RESPONSES TO COMMENTS on the Draft EIR

1500 Mission Street Project

PLANNING DEPARTMENT
CASE NO. 2014-000362ENV

Re: **Attached Responses to Comments on Draft Environmental Impact Report:
Case No. 2014-000362ENV for the 1500 Mission Street Project**

Figure RTC-1
Recently Adopted Area Plans In and Near the 1500 Mission Street Project Site Vicinity

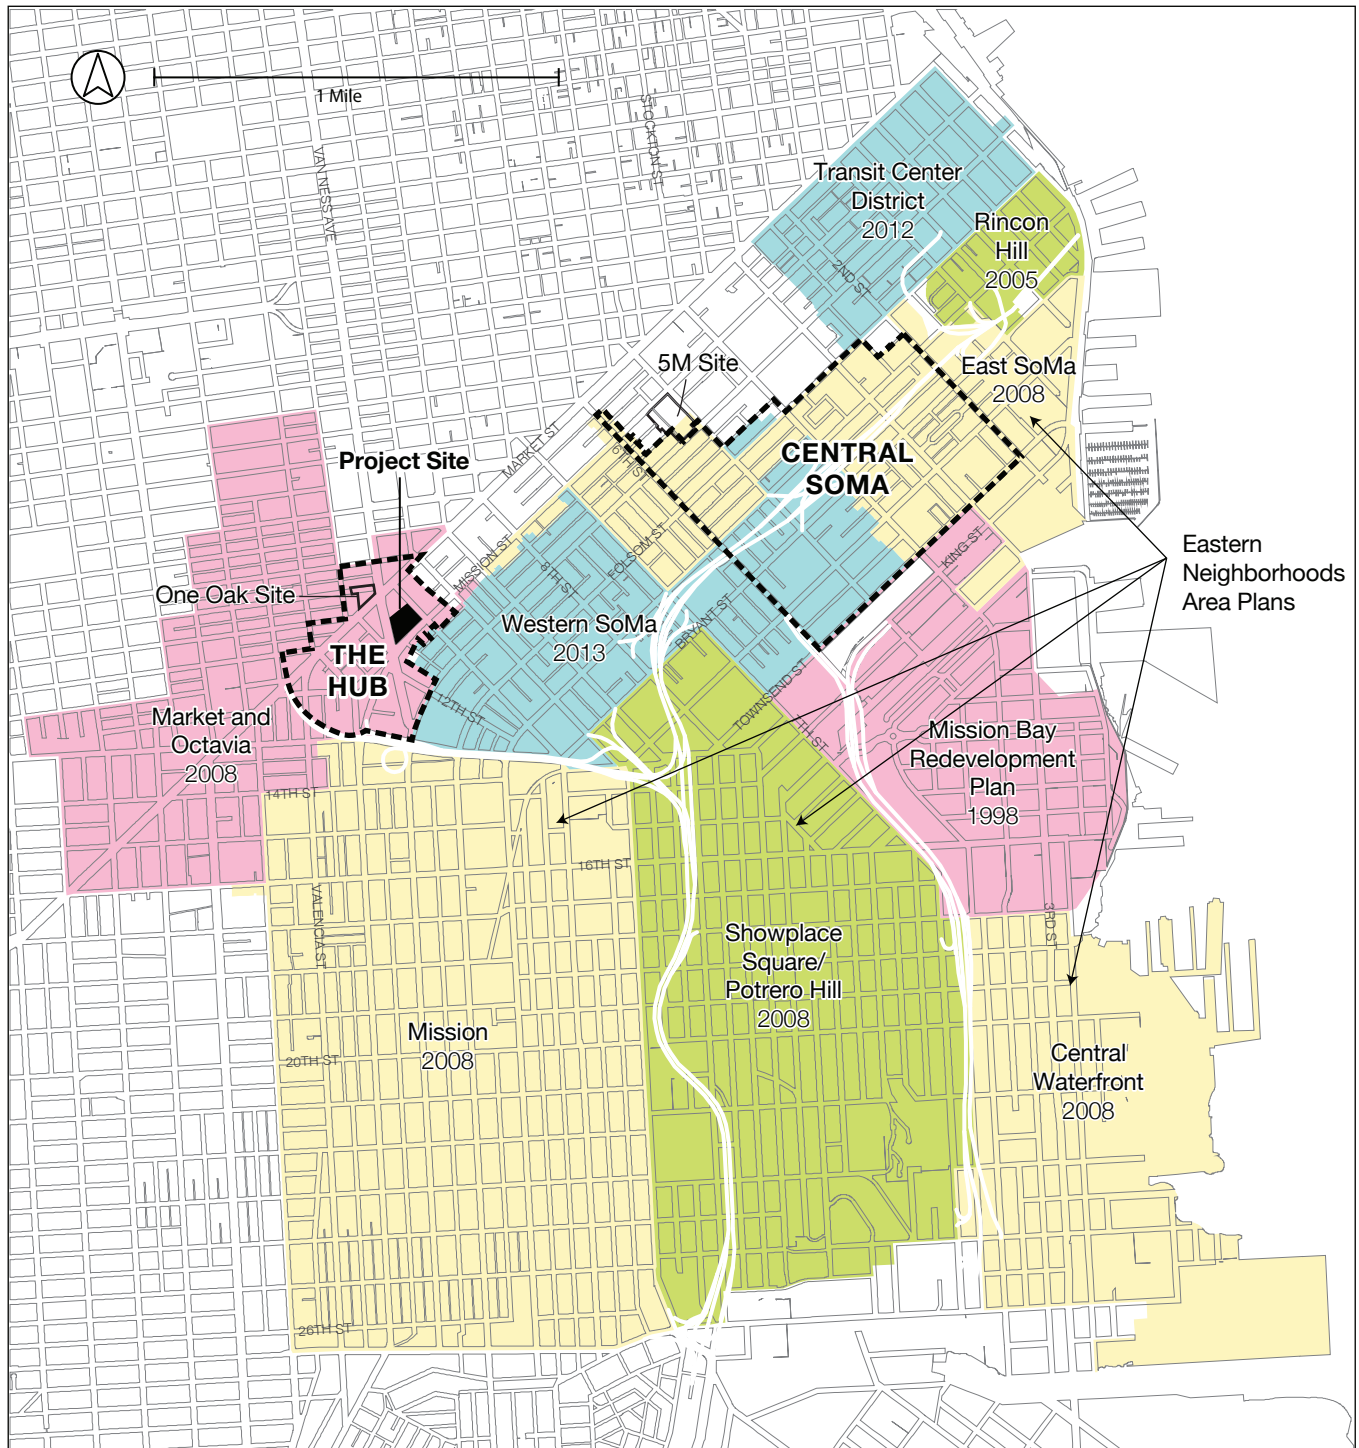
“Two maps must be added to 1500 Mission DEIR

“A map showing the boundaries of the **Market/Octavia Area Plan** PLUS the boundaries of the **Eastern Neighborhoods Area Plan** with its **5 sub-area Plans** (including the **Western SoMa Area Plan**). The M/O plan should show sub-area Van Ness & Market Downtown Residential Special Use District.

“Superimpose on this Map the boundaries of the **proposed Central SoMa Area Plan, The Hub**, and all other Plans that have amended these Area Plans. This would include the **5M plan** at 5th & Market which amended part of the Eastern Neighborhood Area Plan. PLUS any **proposed** Map Amendments to either Market/Octavia or the Eastern Neighborhoods Plan, including those proposed in any pending PPA [Preliminary Project Assessment]. This is the proposed map amendment for One Oak/1500 Market. Also the requested height reclassification on the western end of One Oak/1500 Market block - at Franklin & Oak.

The comment requests further information, including a map, concerning recent planning efforts in the project vicinity, including those for the Market & Octavia area, Eastern Neighborhoods, and Western SoMa, to provide context for the proposed project.

Figure RTC-1, Recently Adopted Area Plans in and near the 1500 Mission Street Project Site Vicinity, page RTC-14, depicts the recently adopted area plans, including the Market & Octavia Area Plan (adopted in 2008), the four Eastern Neighborhoods plans (Mission, Showplace Square/Potrero Hill, Central Waterfront, East SoMa) (adopted in 2008), the Western SoMa Plan (adopted in 2013), Rincon Hill Plan (updated plan adopted in 2005), and Transit Center District Plan (adopted in 2012). The figure also shows the area of the proposed Central SoMa Plan and the area covered by the proposed Hub planning effort. The nearby-proposed One Oak Street Project (1500–1540 Market Street; Case No. 2009.0159E) site is also shown, as is the approved 5M Project site. Each of these plans contains parking maximums, rather than parking minimums.

Figure RTC-4
Historical Photos of 1500 Mission Street Building
(White Motor Company Building)

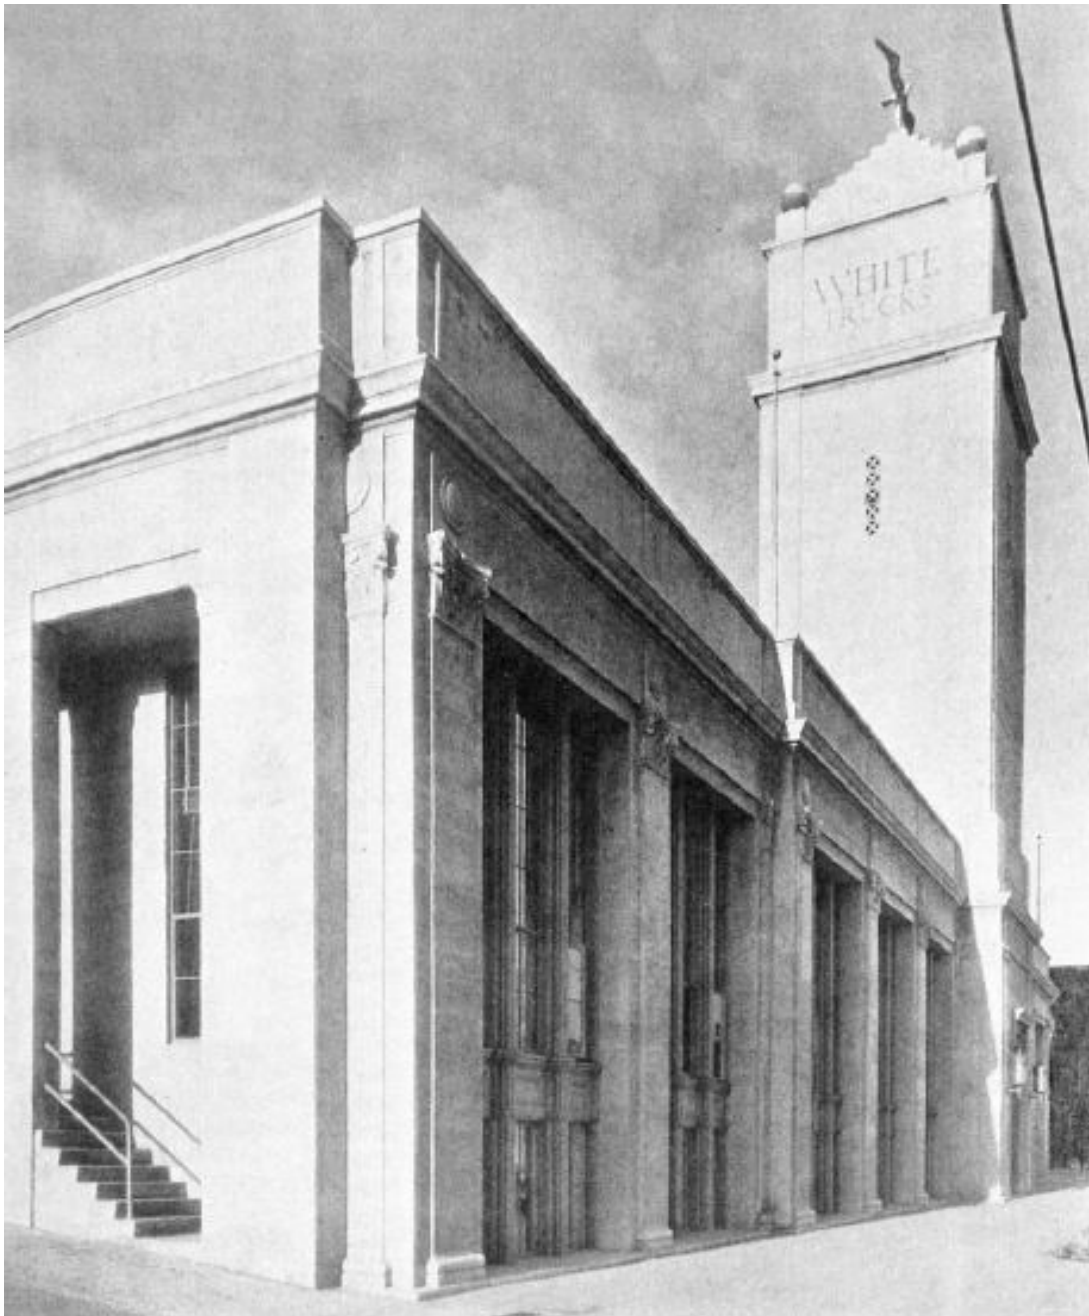
"I'd like to ask that in the historic preservation discussion of the 1500 Mission building that you include historic photos of the building that when it comes to the Final EIR will make it easier for people who are interested to comment to see what it was like. The building has slightly been altered overtime and there would be an emphasis on those elements that will be particularly integrated.

"We all have seen the first discussion on the building which does a very nice job of recognizing the importance of the building, but further elaboration on the background, historic photos would be very helpful, including where the main entrances were so we have a really better appreciation of what is included."(Planning Commissioner Kathrin Moore; Public Hearing Comments, December 15, 2016)

Figure RTC-7
Proposed Wind Screen (detail of Draft EIR Figure II-16)

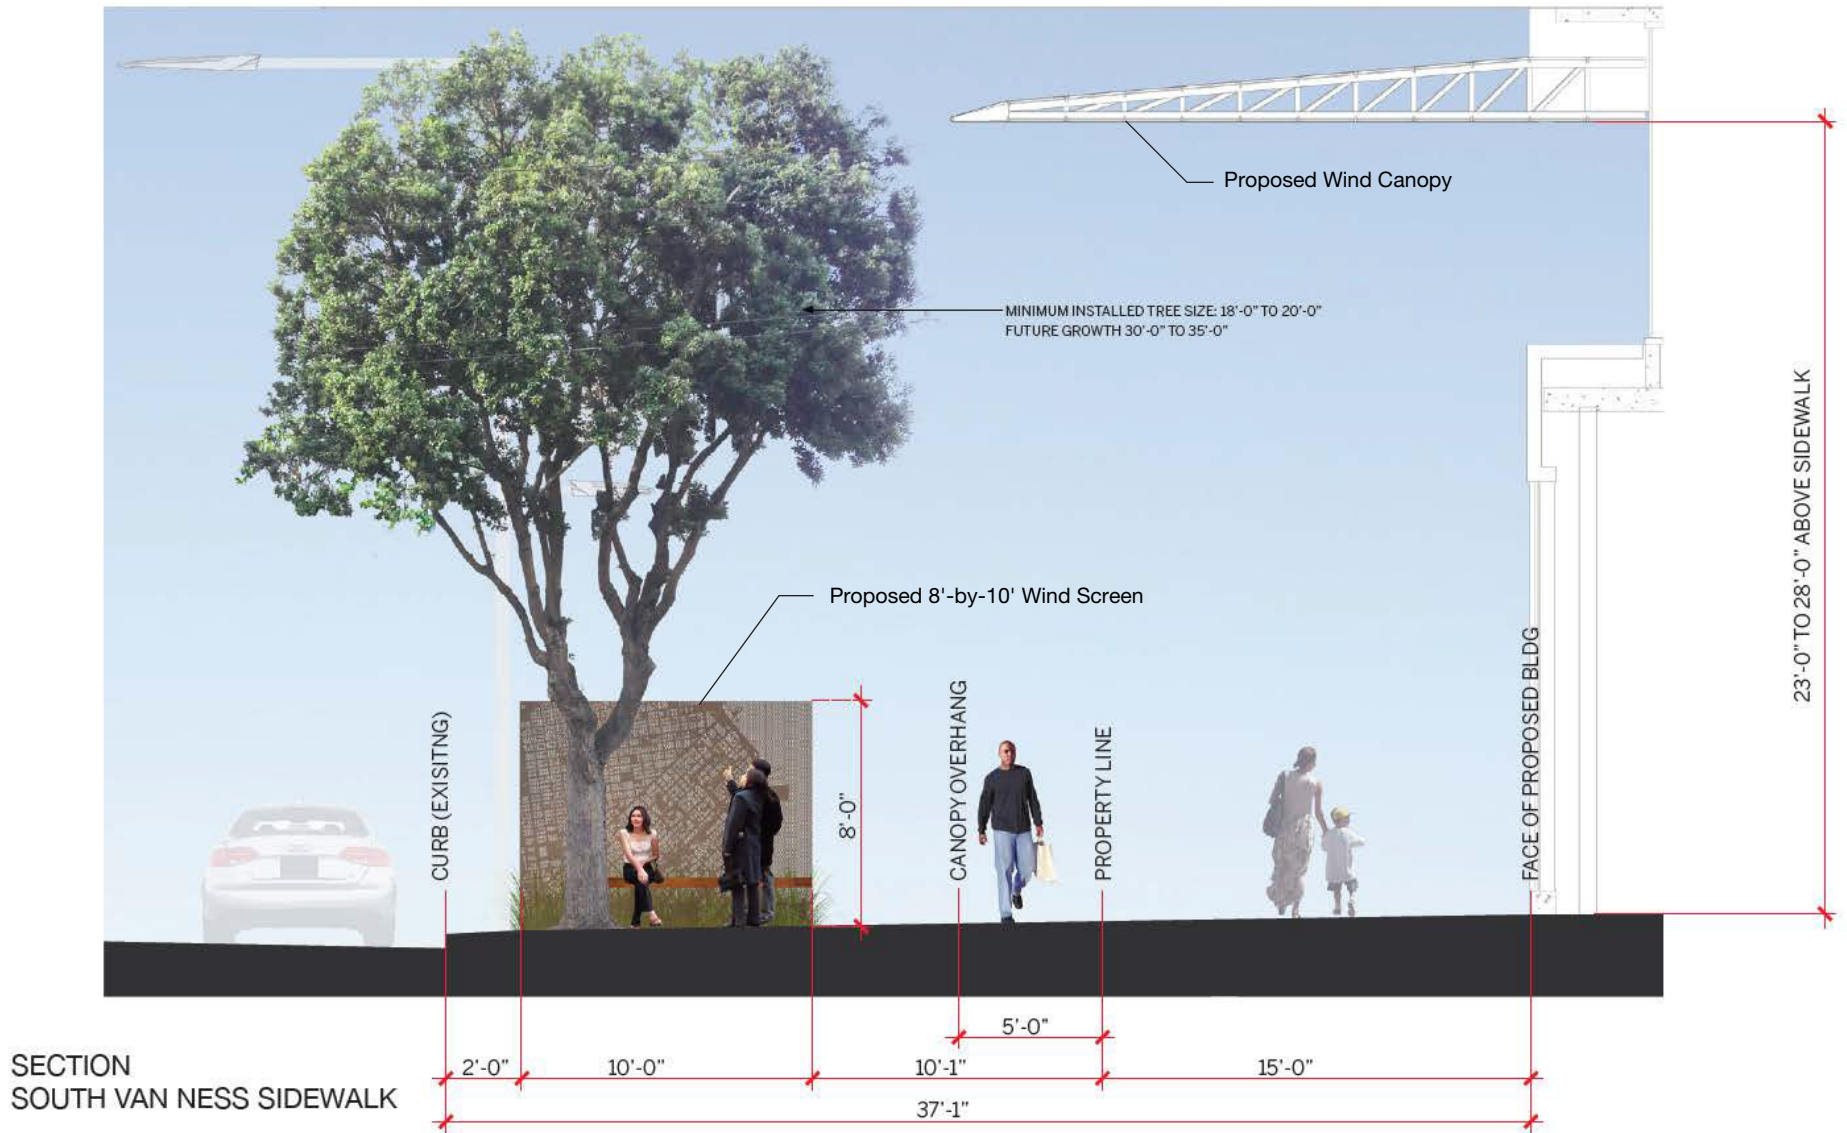
“Please explain and show on visual - **Figure II-16 - the proposed wind screens**. They are hard to understand/see.” (Sue C. Hestor; letter, January 4, 2017)

As stated on Draft EIR page II-23, as revised herein, and illustrated in Draft EIR Figure II-16, Draft EIR page 26, as well as in **Figure RTC-7, Proposed Wind Screen (Detail of Draft EIR Figure II-16)**, page RTC-56, herein, the proposed project would include a wind canopy that would surround the South Van Ness and Mission Street façades of the project’s residential tower at a height of between about 23 and 28 feet above the sidewalk. The wind canopy would be 20 feet wide on South Van Ness Avenue and 14 feet, 9 inches wide along Mission Street. It can be expected that the wind canopy, in addition to protecting pedestrians on the sidewalks surrounding the residential tower, would tend to slow winds and disperse them away from the tower. This is because wind effects of buildings result in relatively higher-speed winds at higher elevations being intercepted by the building and channeled down and around the building walls, accelerating as they descend. Anything that interrupts the flow of the wind rushing down the side of the building will result in lower ground-level wind speeds. This is why towers that are set back from building street walls tend to result in calmer wind conditions at the building base than buildings whose street walls are uninterrupted. The proposed project’s wind canopy would function much as a setback, resulting in lower wind speeds outboard from the canopy (as at the base of a building street wall with a setback tower above), including where a bicycle lane is planned on Mission Street (see below), as well as beneath the canopy, where the canopy would provide direct protection to pedestrians.

As described on Draft EIR page II-25, the proposed project would include “the installation of eight wind screens approximately eight feet tall by 10 feet wide at 40-foot intervals along the South Van Ness Avenue sidewalk adjacent to the project site and perpendicular to the street.” A typical wind screen, anticipated to be approximately 50 percent porous, is illustrated in the top image of Draft EIR Figure II-16, Draft EIR page 26. The wind screens are also visible in Figure II-22, Draft EIR page 35, which presents a view of the proposed project from South Van Ness Avenue. **Figure RTC-7, Proposed Wind Screen (Detail of Draft EIR Figure II-16)**, page RTC-56, and **Figure RTC-8, View of Proposed Wind Screens along South Van Ness Avenue (Detail of Draft EIR Figure II-22)**, page RTC-58, present enlargements of portions of Draft EIR Figure II-16 and Figure II-22 to more clearly depict the proposed wind screens.
